<b>Docket Number:</b>	13-AFC-01
<b>Project Title:</b>	Alamitos Energy Center
<b>TN #:</b>	214882
<b>Document Title:</b>	Intervenor Part 2 opening testimony (revised final redlined version)
<b>Description:</b>	Opening Testimony Part 2 REVISED (to replace TN 214853)
<b>Filer:</b>	ELIZABETH LAMBE
<b>Organization:</b>	Los Cerritos Wetlands Land Trust
<b>Submitter Role:</b>	Intervenor
<b>Submission Date:</b>	12/19/2016 7:15:03 AM
<b>Docketed Date:</b>	12/19/2016

**INTERVENOR LOS CERRITOS WETLANDS LAND TRUST  
Part Two Opening Testimony**

**Sections 1 and 2: Testimony of Bill Powers on behalf of the Trust  
Sections 3, 4 and 5: Testimony of Joe Geever on behalf of the Trust**

**Figure 1. Start-up timelines of Flex-Plant™ and conventional combined cycle plants<sup>12</sup>**

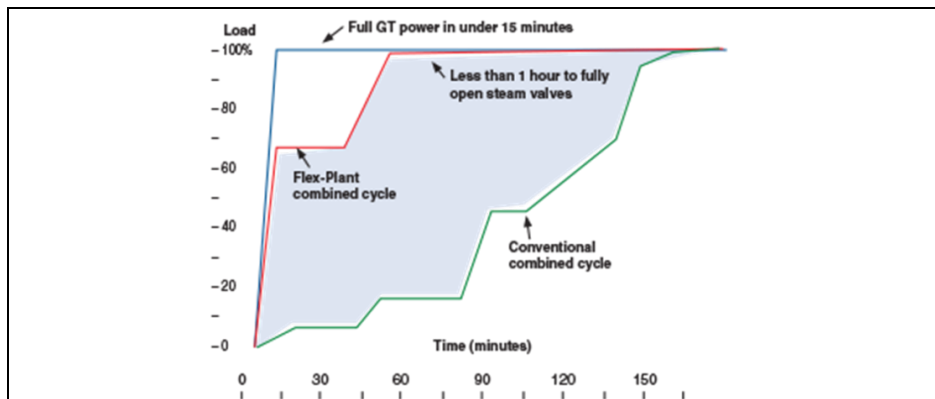
However, the 640 MW combined cycle component of the AEC does not meet the “less than 30 minutes” timeline to full power that defines the term fast start as used by the CPUC and the CAISO. The fastest start combined cycle configuration available on the market at this time is the Siemens combined cycle “Flex-Plant™” technology in use at the 550 MW El Segundo Energy Center that is owned by NRG and became operational in 2013.<sup>10</sup> This combined cycle technology can provide about 55 percent of its rated capacity in 10 minutes, and requires approximately one hour to reach its full 550 MW rating.<sup>11</sup>

The Siemens Flex-Plant™ combined cycle technology is specifically designed to start as fast as possible, much more quickly than conventional combined cycle configurations, as shown in Figure 1. The GE Frame 7A.05 combined cycle technology proposed by AES for use in the AEC combined cycle block is slower start technology than the Siemens Flex-Plant™ combined cycle technology at El Segundo. The GE Frame 7A.05 is conventional combined cycle technology. As shown in Figure 1, conventional combined cycle technology provides little power at 10 minutes or 30 minutes into start-up, and takes 2-3 hours to reach full power.

A conventional combined cycle unit produces less than 10 percent of its rated output at 30 minutes, less than 20 percent at 60 minutes, and requires over two hours to reach full power. The GE Frame 7A.05 combined cycle configuration cannot be considered a fast start technology under the definition used by the CPUC and CAISO. The GE Frame 7A.05 does not meet a primary project defined in the FSA for the AEC. It is not fast start technology. In contrast, the GE LMS100 is designed to reach full power in 10 minutes or less and meets the CPUC and CAISO definition of a fast start resource.
